# SERVICE LETTER

No. 654

Piper Aircraft Corporation

Heater Control System Modification

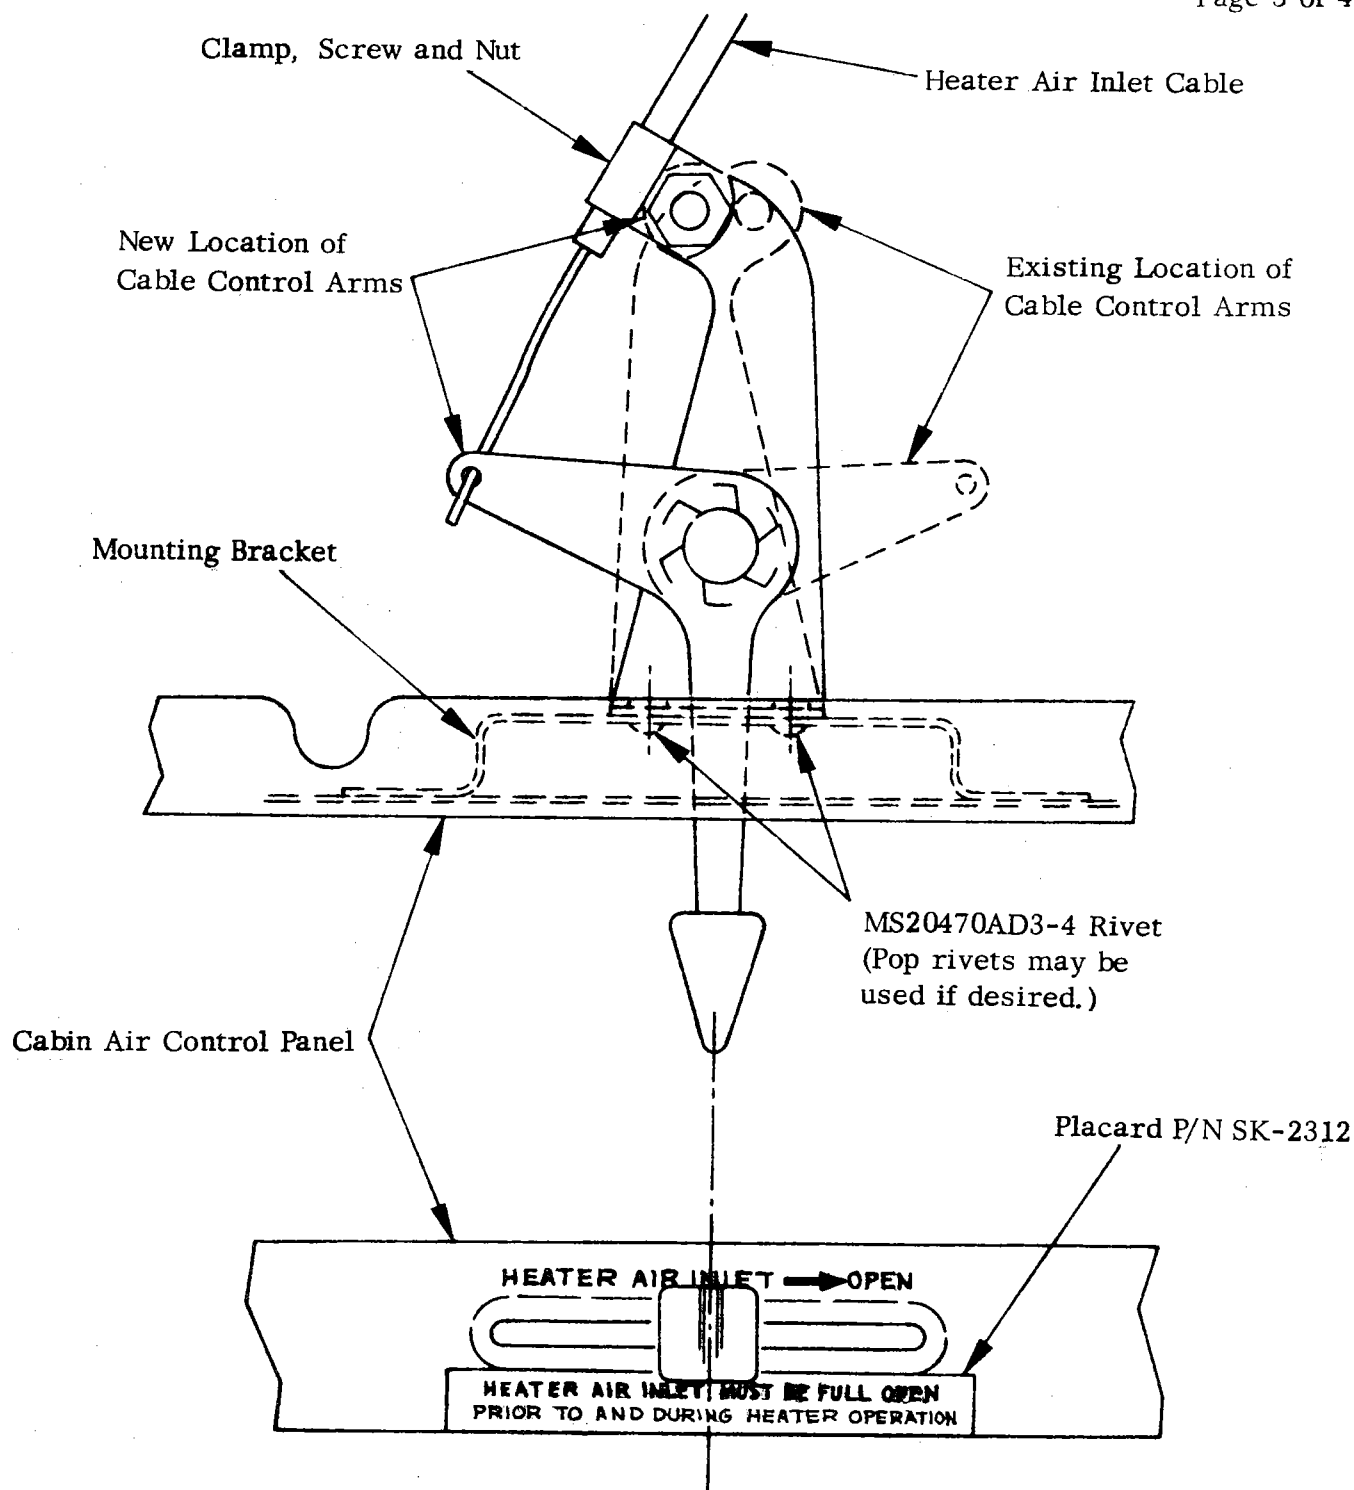
1. Remove heater air inlet cable from control arm.
2. Remove two rivets that attach the control arm assembly to the mounting bracket.
3. Position the arm assembly on the mounting bracket as shown above, and attach with two rivets.
4. Attach the cable to the arm and secure in place using existing clamp, screw and nut.
5. Install placard P/N SK-2312 on the face of the cabin air control panel as shown above.
